**Economic and Social Council**Distr.: General
30 January 2024

World Forum for Harmonization of Vehicle Regulations**Working Party on General Safety Provisions****127th session**

UN Regulation No. 118 (Fire resistance of interior materials)**Proposal for the Supplement 1 to the 01 Series of
Amendments to UN Regulation No. 118 (Fire resistance of
interior materials)****Submitted by the expert from the European Association of Automotive
Suppliers ***

Insert new paragraph 4.4.3.1., to read:

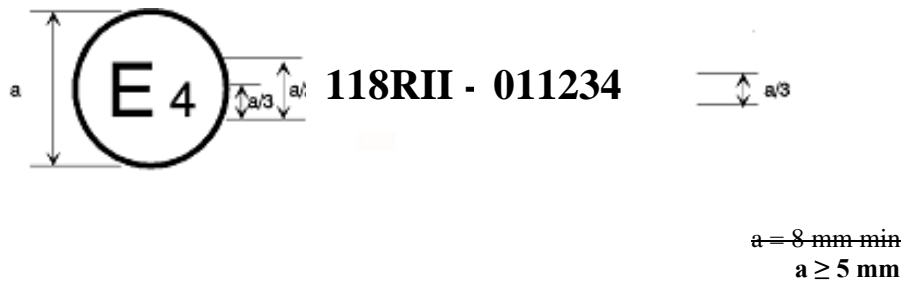
"4.4.3.1. If the component conforms to a component type approved, under one or more other Regulations annexed to the Agreement, in the country which has granted approval under this Regulation, the symbol prescribed in paragraph 4.4.1. above need not be repeated; in such a case, the Regulation and approval numbers and the additional symbols of all the Regulations under which approval has been granted in the country which has granted approval under this Regulation shall be placed in rows to the right of the symbol prescribed in paragraph 4.4.1. above."
